City of York Local Plan Modifications Consultation 2023

MM3.17 Policy SS8: Land Adjacent to Hull Road

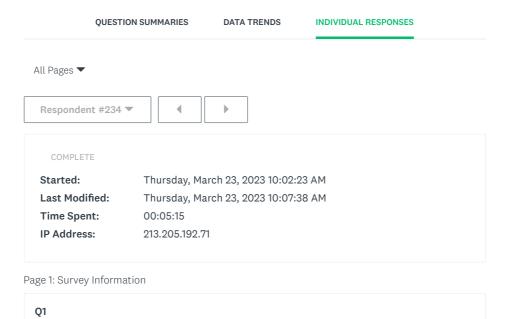
Congestion at peak times is already a problem in Heslington (see photo below). Together, the intended developments ST4, ST27, ST15 will send greatly increased traffic through Heslington Parish down Field Lane into Main Street West and University Road as well as into Main Street South to access the facilities there. Coupled with the suggested cycle routes through Heslington from Wheldrake, Elvington, Langwith Garden Village (ST15) and further afield (eg Fulford), the cumulative traffic impact on Heslington from the draft Local Plan is unacceptable. The disruption to Heslington Conservation Area, and to residents and businesses throughout the Parish, would be considerable with inevitable increased congestion and its consequent negative effects. Please see also positive suggestions in Supporting Documentation for Spatial Strategy MM3.17, MM3.54, MM3.58, MM3.77.

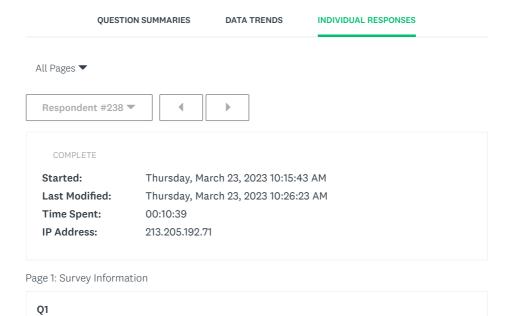
Congestion at peak times is already a problem in Heslington (see photo below). Together, the intended developments ST4, ST27, ST15 will send greatly increased traffic through Heslington Parish down Field Lane into Main Street West and University Road as well as into Main Street South to access the facilities there. Coupled with the suggested cycle routes through Heslington from Wheldrake, Elvington, Langwith Garden Village (ST15) and further afield (eg Fulford), the cumulative traffic impact on Heslington from the draft Local Plan is unacceptable. The disruption to Heslington Conservation Area, and to residents and businesses throughout the Parish, would be considerable with inevitable increased congestion and its consequent negative effects. Please see also positive suggestions in Supporting Documentation for Spatial Strategy MM3.17, MM3.54, MM3.58, MM3.77.

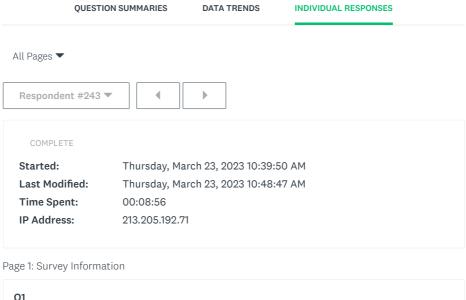
Congestion at peak times is already a problem in Heslington (see photo below). Together, the intended developments ST4, ST27, ST15 will send greatly increased traffic through Heslington Parish down Field Lane into Main Street West and University Road as well as into Main Street South to access the facilities there. Coupled with the suggested cycle routes through Heslington from Wheldrake, Elvington, Langwith Garden Village (ST15) and further afield (eg Fulford), the cumulative traffic impact on Heslington from the draft Local Plan is unacceptable. The disruption to Heslington Conservation Area, and to residents and businesses throughout the Parish, would be considerable with inevitable increased congestion and its consequent negative effects. Please see also positive suggestions in Supporting Documentation for Spatial Strategy MM3.17, MM3.54, MM3.58, MM3.77.
